**Apartments 402 & 404 Middle Warehouse, Castle Quay
Independent Report & Advice on Rainwater Incursion Experienced**

1. Purpose, Background & Scope of Report:

Potential for rainwater ingress to exploit the jointing to the lead sheet when the gutter is holding water.

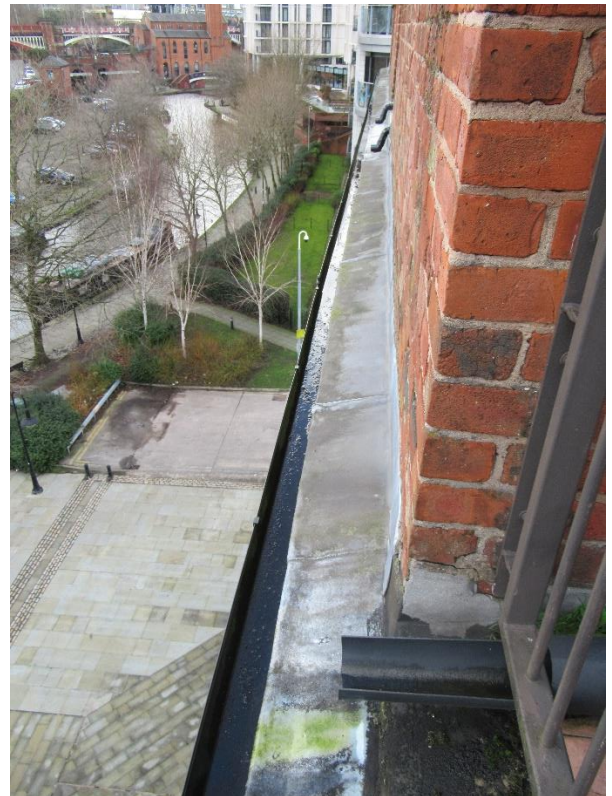
Lead designed and installed as per LSA recommendations will perform perfectly well so long as the gutters are shedding water; however, as soon as water builds up in a gutter there is a risk that the jointing to the sheet lead will be breached – this type of jointed lead is not designed to hold or sit under water. Below are several photographs which show the joint details to the leadwork and a clear silt / algae line i.e. tide-mark, indicating that rainwater does build-up above and beyond the joint.

Given the length of the guttering the sections of lead have been jointed to prevent splitting.

Lap joint to sheet lead designed to accommodate thermal expansion and contraction in the material.

Standard joints to lengths of leadwork, sole and walls.

This is another element of construction that has been flagged for further investigation. If water builds-up within these gutters during heavy rainfall, which I suspect it does (evidence points to this), the lead weathering details will allow water to penetrate the fabric, unless there is a secondary weather-proofing barrier beneath this, which I doubt.

A simple solution in this case might be to cover the lead with a fleece and built-up liquid plastic waterproofing to form a seamless gutter, to eliminate the reliance on jointed sheet lead.

Obvious splits and defects to the asphalt to 505 terrace – remote from both 402 and 404 but included for context.

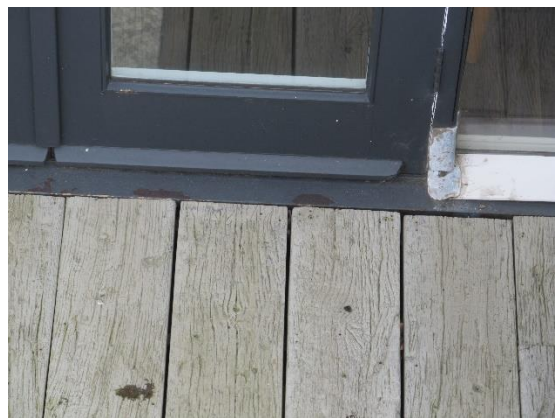
Typical example of cracked / fissured asphalt to the upstand skirting to 502 roof terrace.

Retrospective lead saddle / bandage repair where electrical cables pass through the waterproofing to 504 Terrace.

Whilst there are several minor cracks and splits within the asphalt above 402, it seems unlikely that these would give rise to the reported issues post heavy rain. Notwithstanding, they need to be addressed and should be swept up with any future Planned Maintenance Works.

In respect of the ingress to 404, I cannot eliminate the roof terrace weathering details to 504 as a potential cause and certainly the repairs affected to the patio screen base rail with lead should be further investigated.
